**INSTRUCTION TO SERVICE ITS: 4947**

| SECTION:<br>260<br><br>Battery<br>Compartment | MODEL:<br><input type="checkbox"/> 30FT <input type="checkbox"/> 35FT <input checked="" type="checkbox"/> 40FT <input type="checkbox"/> 60FT<br><br><input type="checkbox"/> DSL <input type="checkbox"/> CNG <input type="checkbox"/> LNG <input checked="" type="checkbox"/> XDE | TYPE:<br><input checked="" type="checkbox"/> Xcelsior<br><br><input type="checkbox"/> LOW FLOOR | WRITTEN BY:<br>Mike Pearson |

OBJECTIVE/SUBJECT:  
Provide instructions to upgrade the BAE Energy Storage System.

Electrical Diagram of Center Pack Contactor Upgrade

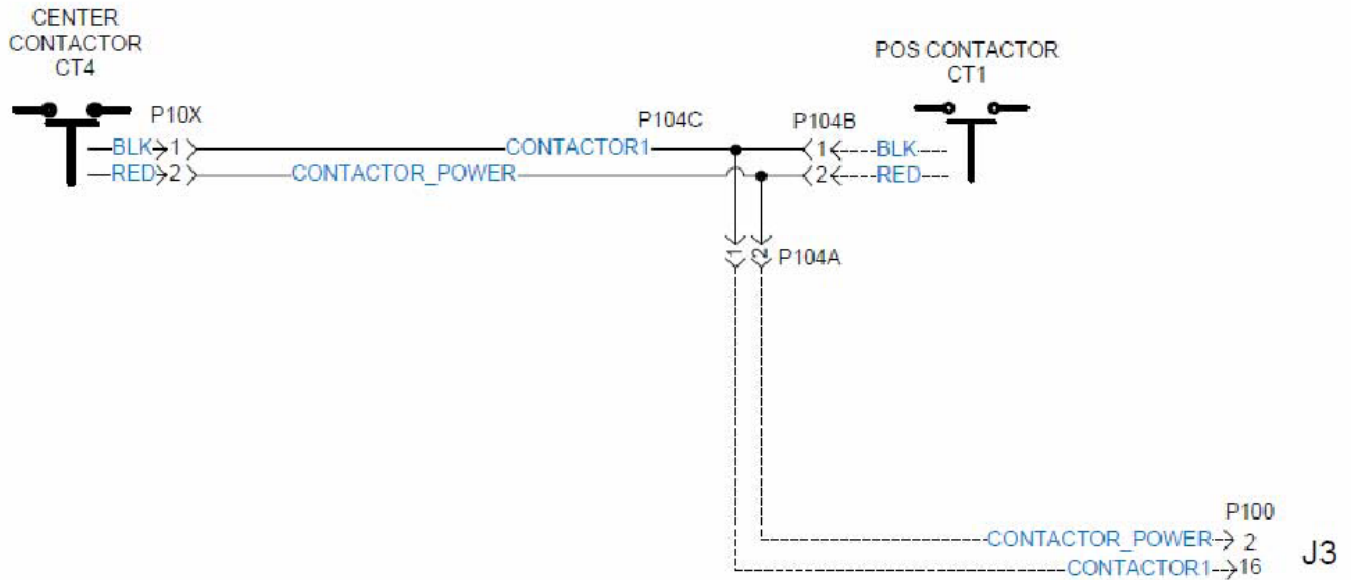
- e. Remove PVC Insulating Blankets.
- f. Inspect the yellow sense wire in the area of the Positive Contactor for damage to make sure that it is not pinched between the contactor and the skin of the ESS.
- g. Remove Center 250A Fuse.
  1. Remove the two Lock Nuts (P/N 400969-005). Split (P/N 400968-007) and Flat Washers (PN 400959-018) that secure the Fuse ( ITEM 1 P/N 400287-002) to the Bus Bar. Only remove the hardware that secures the Fuse (P/N 400287-002) to the Bus Bar.
  2. Loosen the Captive Screws on the Midpack Bus Bars and remove them from the Tub. Be sure to hold them while loosening the captive hardware to prevent them from falling into the tub. Discard both center Fuse brackets.
  3. Remove the Fuse (ITEM 1: P/N 400287-002) from Fuse Holder Posts & discard Fuse.
  4. Remove the center fuse insulated standoffs and discard.
- h. Replace Center 250A Fuse with Center Contactor.

☞ **NOTE: Contactor (P/N 400698-001) power terminals have a polarity (marked A1 & A2).**

1. Install Center Contactor Bracket (P/N 407219-001) with two Pan Head screws (P/N 900017-1053). Torque to 28-32 lb\*in (3.16-3.61 N\*m).
2. Line up the Contactor (P/N 400698-001) with the screw locations.
3. Use two Pan Head Screws (P/N 900017-1053) and two Flat Washers (P/N 900862-001) to secure contactor to the bracket. Torque screws to 28-32 lb\*in (3.16-3.61N\*m).

4. Use the two Hex Lock Nuts (P/N 400969-005), Split (P/N 400968-007) and Flat Washers (P/N 400959-018) to secure the Center Contactor Positive Bus Bar (P/N 407220-001) and Center Contactor Negative Bus Bar (P/N 407221-001) to the Center Contactor. Finger tighten the Lock nuts.
5. Disconnect the Positive Contactor wire harness.
6. Install new Wire Harness (P/N 407415-001) from Positive Contactor to Center Contactor. Route wire harness under steel tube.
7. Using two Tie Straps (P/N 403968-584) together, affix contactor harness to steel tubing.
